Project	IEEE 802.16 Broadband Wireless Access Working Group < http://ieee802.org/16 >		
Title	Corrections for AAS Diversity-Map Scan in OFDMA PHY		
Date Submitted	2004-11-12		
Source(s)	Yuval Lomnitz, Hassan Yaghoobi	Intel Corp	yuval.lomnitz@intel.com , hassan.yaghoobi@intel.com
	Tal Kaitz, Ran Yaniv	Alvarion	tal.kaitz@alvarion.com , ran.yaniv@alvarion.com
	Dave Pechner, Todd Chauvin, Doug Dahlby, Adam Kerr	ArrayComm Inc.	dpechner@arraycomm.com , dahlby@arraycomm.com , adam@arraycomm.com , chauvin@arraycomm.com
Re:	IEEE P802.16-REVd/D5		
Abstract	This contribution introduces corrections for support of AAS Diversity-Map Scan in the OFDMA PHY		
Purpose	Adopt into P802.16d/D5 corrigenda		
Notice	This document has been prepared to assist IEEE 802.16. It is offered as a basis for discussion and is not binding on the contributing individual(s) or organization(s). The material in this document is subject to change in form and content after further study. The contributor(s) reserve(s) the right to add, amend or withdraw material contained herein.

Corrections for AAS Diversity-Map Scan in OFDMA PHY

[Replace figure 224 with the following]

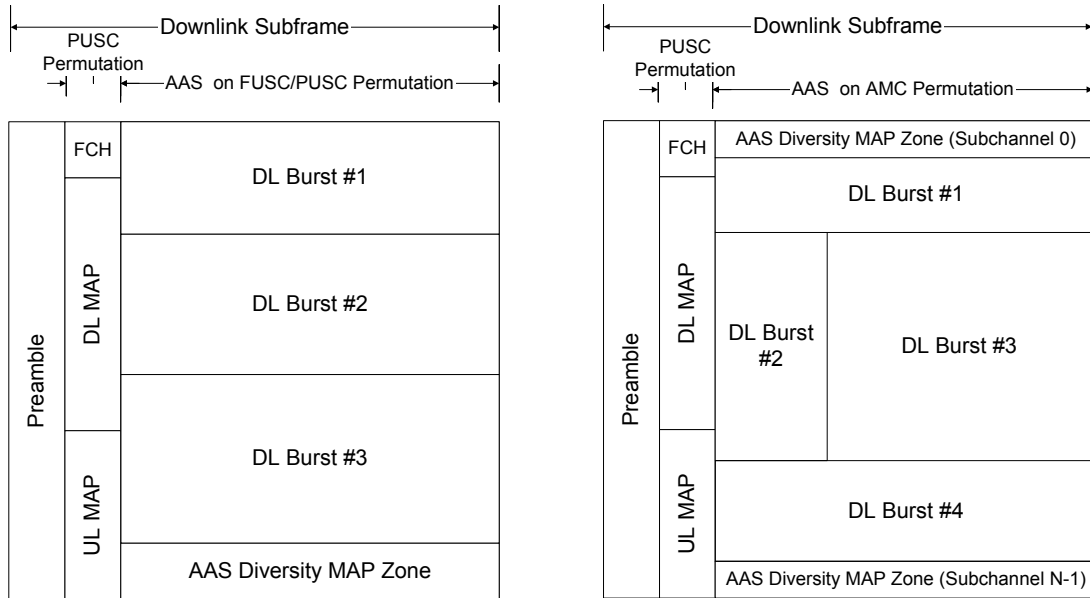
It is assumed that all AAS subscribers will be able to determine the IDcell used in the selection of the DL preamble at the beginning of the DL frame. This IDcell shall be used as the DL_PermBase for the AAS zone. The UL_PermBase for the UL zone referred to by the initial ranging allocation in the AAS-DLFP shall be that provided in the UCD message. For AAS subscribers that cannot detect the AAS_DL_IE transmitted in the DL-MAP which specifies the boundaries and permutation of AAS DL zones, they must search over the possible permutations (PUSC/FUSC/AMC) and starting symbol to detect the AAS-DLFP. The permutation for the AAS UL Zone is specified by a field in the AAS-DLFP.
